Subject
V300011 / V400011/ V400021 Water Pump Compatibility

System or Parts affected

Figure 1 – Identifying compatible secondary cooling system water pump

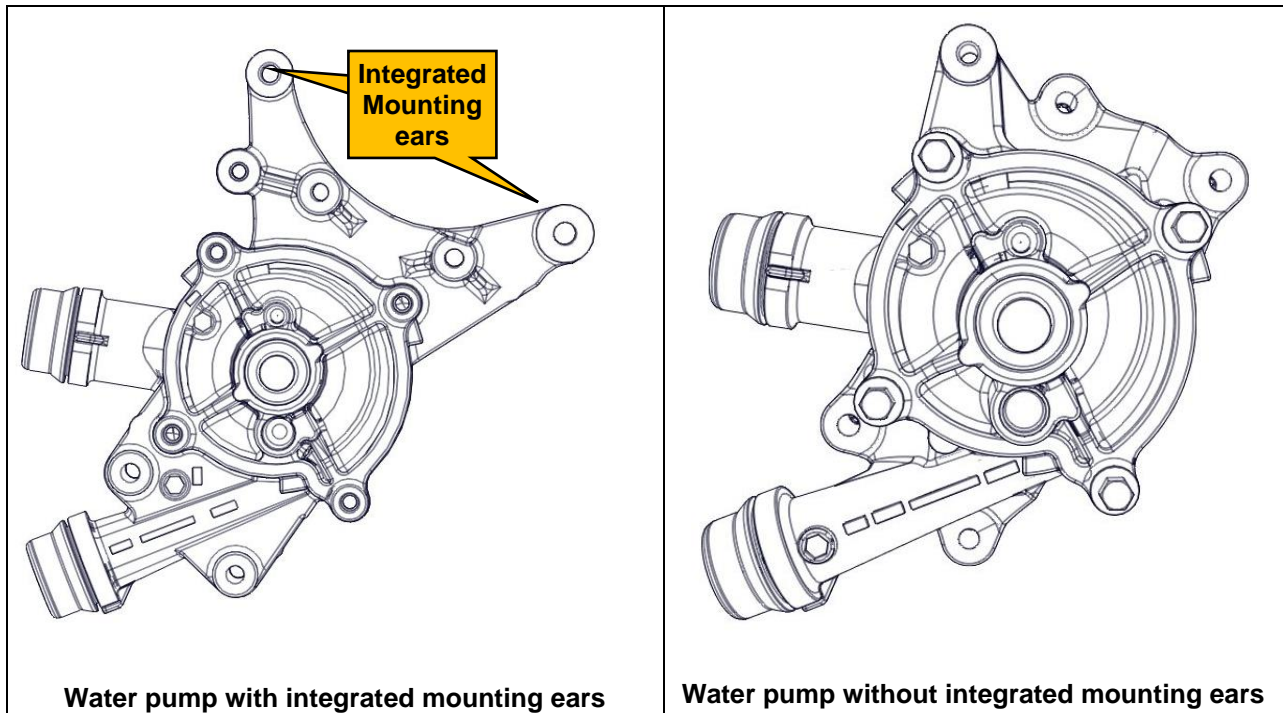
The V300011, V400011, AND V400021 UNDERHOOD™ compressor systems are designed to fit vehicles that are equipped with secondary cooling system water pumps that have integrated mounting ears.

If the vehicle is not equipped with a secondary cooling system water pump with integrated mounting ears, the following adaptor kits must be ordered prior to fitting main bracket (Figure 1):

- V300011 and V400011 - VMAC adaptor kit P/N: A900018
- V400021 - VMAC adaptor kit P/N: A900022
